ANNEX 8**RESOLUTION MSC.222(82)****(adopted on 8 December 2006)****ADOPTION OF AMENDMENTS TO THE INTERNATIONAL CODE
OF SAFETY FOR HIGH-SPEED CRAFT, 2000**

**AMENDMENTS TO THE INTERNATIONAL CODE OF SAFETY
FOR HIGH-SPEED CRAFT, 2000**

Figure 2.6.7a

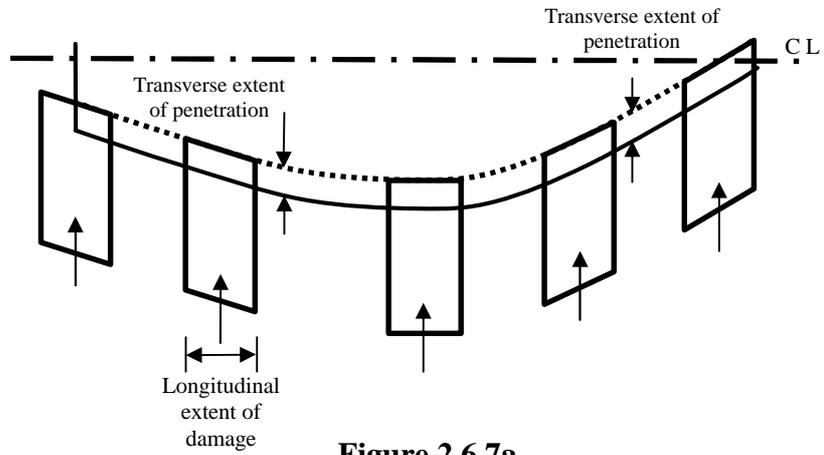
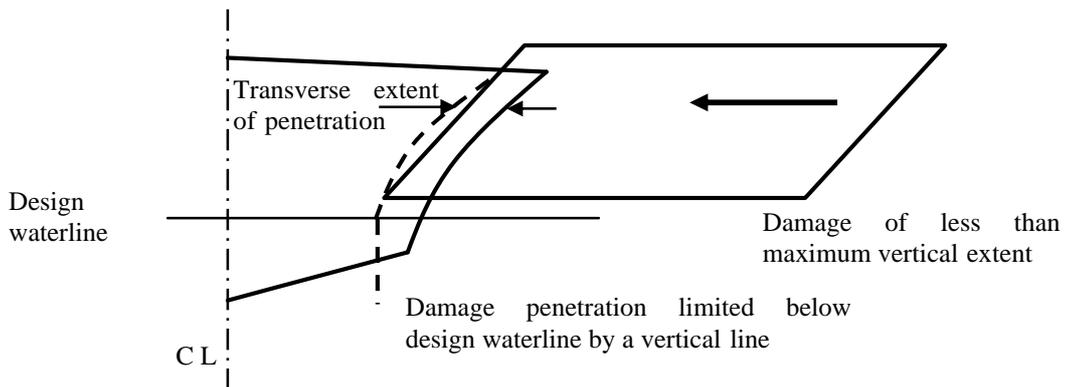
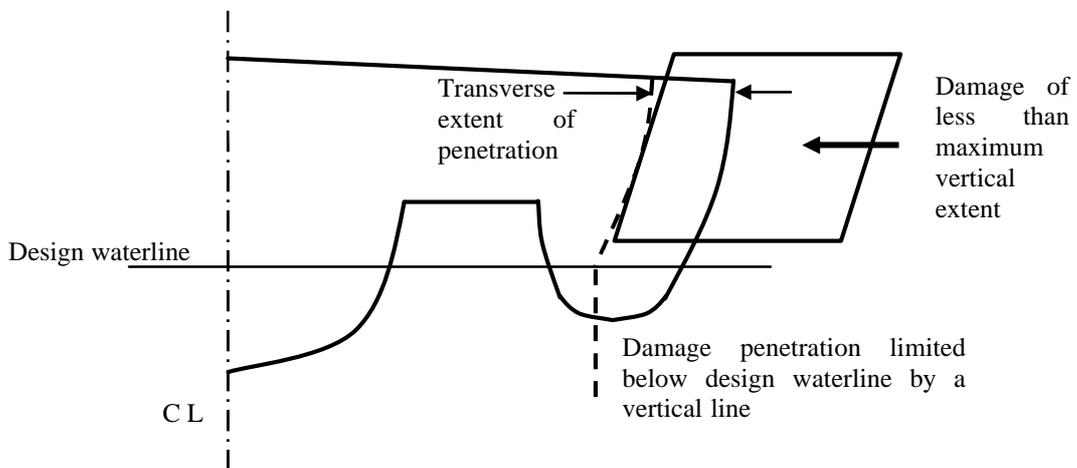
“The damages described in this paragraph shall be assumed to have the shape of a parallelepiped.* Applying this to figure 2.6.7 a, the inboard face at its mid-length shall be tangential to, or otherwise touching in a least 2 places, the surface corresponding to the specified transverse extent of penetration, as illustrated in figure 2.6.7 a.

Side damage shall not transversely penetrate a greater distance than the extent of $0.2V^{1/3}$ at the design waterline, except where a lesser extent is provided for in 2.6.7.2. Refer to figures 2.6.7b and c.

If considering a multihull, the periphery of the craft is considered to only be the surface of the shell encompassed by the outboard surface of the outermost hull at any given section.

Figure 2.6.8”

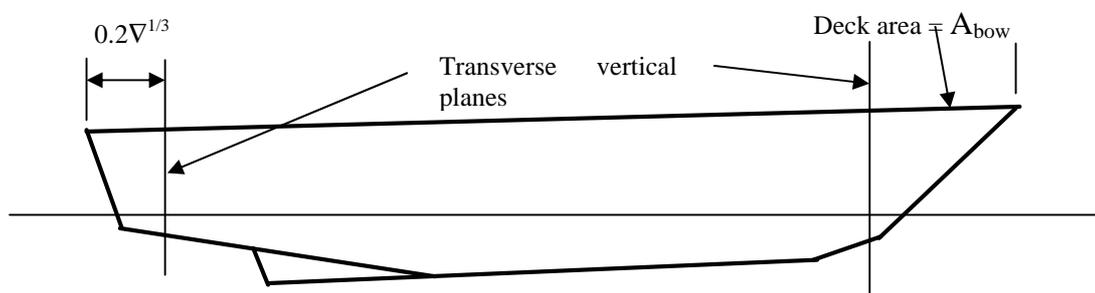
2.6.8.1 The following extents of damage are to be applied to bow and stern, as illustrated in figure 2.6.8:

- .1 at the fore end, damage to the area defined as A_{bow} in 4.4.1, the aft limit of which being a transverse vertical plane, provided that this area need not extend further aft from the forward extremity of the craft’s watertight envelope than the distance defined in 2.6.7.1; and
- .2 at the aft end, damage to the area aft of a transverse vertical plane at a distance $0.2\nabla^{1/3}$ forward of the aft extremity of the watertight envelope of the hull.

2.6.8.2 The provisions of 2.6.6 in relation to damage of lesser extent remain applicable to such damage.

Figure 2.6.9.2

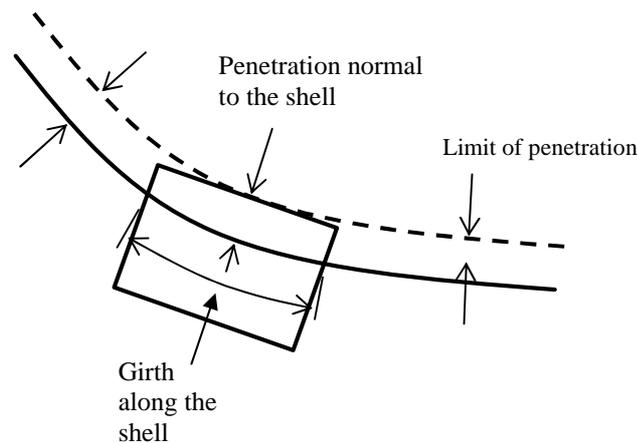
“2.6.9.2.3 The shape of damage shall be assumed to be rectangular in the transverse plane as illustrated in figure 2.6.9.2 below. Damage is to be assumed at a series of sections within the defined longitudinal extent in accordance with figure 2.6.9.2, the mid-point of the damaged girth being maintained at a constant distance from the centreline throughout that longitudinal extent.

“.4 the shape of damage shall be assumed to be rectangular in the plane of the shell of the craft, and rectangular in the transverse plane as illustrated in figure 2.6.9.2.”

Figure 7.3.4a

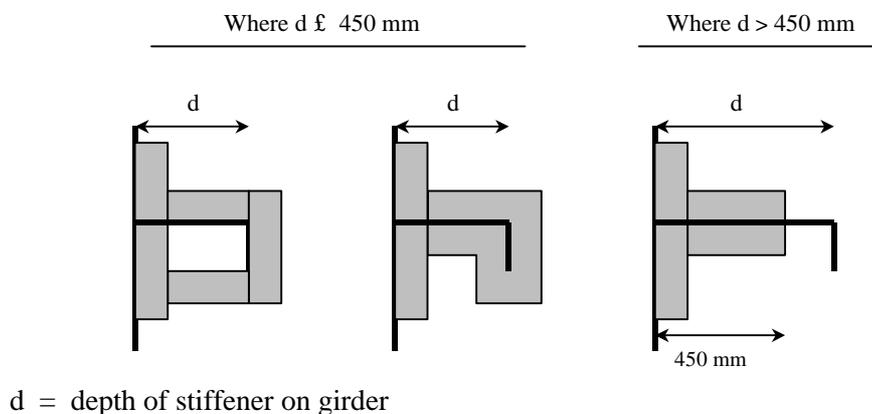
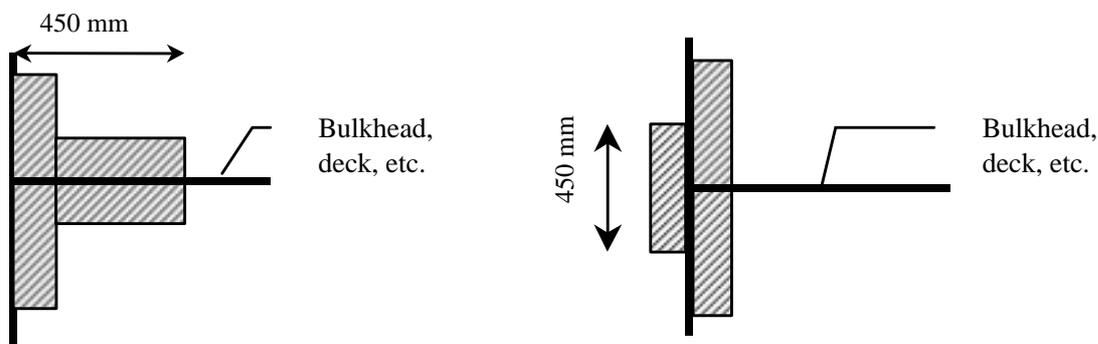
“7.3.4 To prevent heat transmission at intersections and terminal points, the insulation of the deck or bulkhead shall be carried past the intersection or terminal point for a distance of at least 450 mm in the case of steel or aluminium structures (refer to figures 7.3.4a and 7.3.4b).

Figure 7.3.6

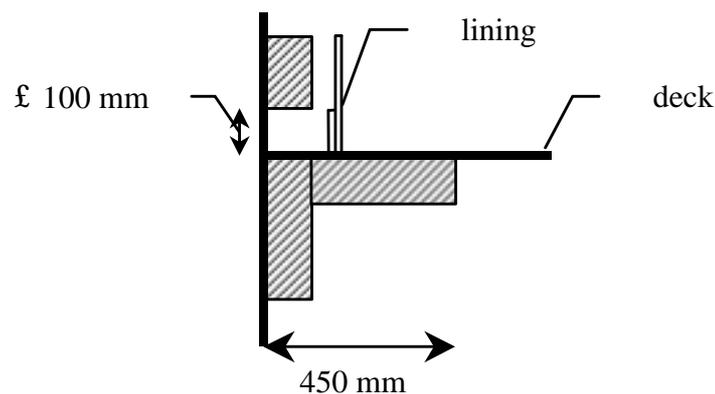
7.3.6 Where the lower part of the fire insulation has to be cut for drainage, the construction shall be in accordance with the structural details shown in figure 7.3.6.”
